# Access Compliance Report

## Public Rights-of-Way

### (Curb Ramps)

Intersection ID: 46748	Main Street: SUPERIOR_ST	Cross Street: NORMANS_LANDING_DR	Location: W
ADA ID: C39B354E4E68	Ramp Type: BlendTrans1	Initial Pass/Fail: Fail	Overall Compliance: No
		Severity Score: 1.25

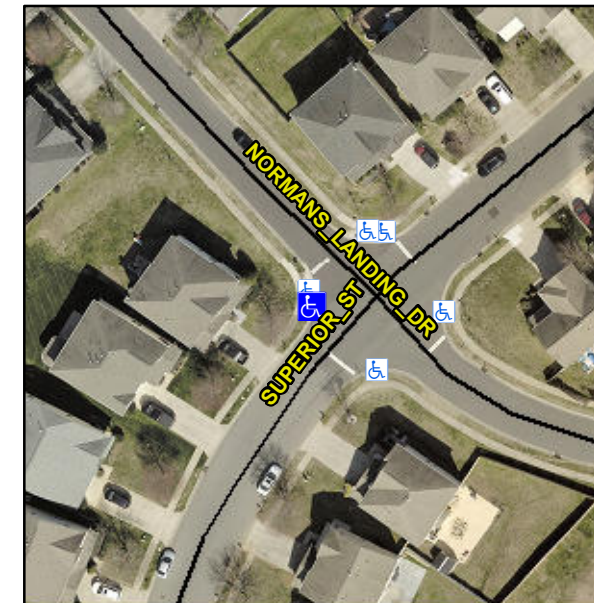
**Not Found, R304.5.3**

Compliance	Description	Data	Compliance	Description	Data
N/A	Ramp Length (in)	48.0	Yes	BlendTrans Slope (%)	4.0
Yes	Ramp Width (in)	60.0	No	BlendTrans XSlope (%)	3.5
N/A	Flare Type LT	N/A	N/A	Flare Type RT	N/A
N/A	Flare Slope LT (%)	N/A	N/A	Flare Slope RT (%)	N/A
N/A	Flare Traversable LT?	N/A	N/A	Flare Traversable RT?	N/A
N/A	Landing Length (in)	N/A	N/A	DWS Provided?	N/A
N/A	Landing Width (in)	N/A	N/A	DWS Contrast?	N/A
N/A	Landing Slope (%)	N/A	N/A	DWS Length (in)	N/A
N/A	Landing X Slope (%)	N/A	N/A	DWS Full Width?	N/A
N/A	Landing Curb? (Y/N)	N/A	N/A	DWS Offset (in)	N/A
N/A	Shared Landing?	N/A			
N/A	Gutter Ponding?	N/A	N/A	Gutter Slope (%)	N/A
N/A	Gutter Lip Ht (in)	N/A	N/A	Gutter X Slope (%)	N/A
N/A	Painted X Walk1?	No	N/A	Painted X Walk2?	N/A
	X Walk 1 Direction	To SE		X Walk 2 Direction	N/A
	X Walk 1 Width (in)	N/A		X Walk 2 Width (in)	N/A
	X Walk 1 Slope (%)	3.0		X Walk 2 Slope (%)	N/A
	X Walk 1 X Slope (%)	2.9		X Walk 2 X Slope (%)	N/A

N/A	Ramp inside XWalk1?	N/A	N/A	Ramp inside XWalk2?	N/A
	Road Slope (%)	2.9		Clear Space?	N/A
	Road X Slope (%)	3.0	N/A	Clear Space to XWalk (in)	N/A
N/A	Any Obstructions?	N/A	N/A	Storm Grate/Utility Hazard?	N/A
	Obstruction Type			Storm Grate/Utility Type	
		N/A			N/A
			Yes	Surface Condition? (G/P)	Good
			No	Curb Slope (%)	12.9

**Remove & Replace Curb Ramp With Two New Directional Ramps or Equivalent.**
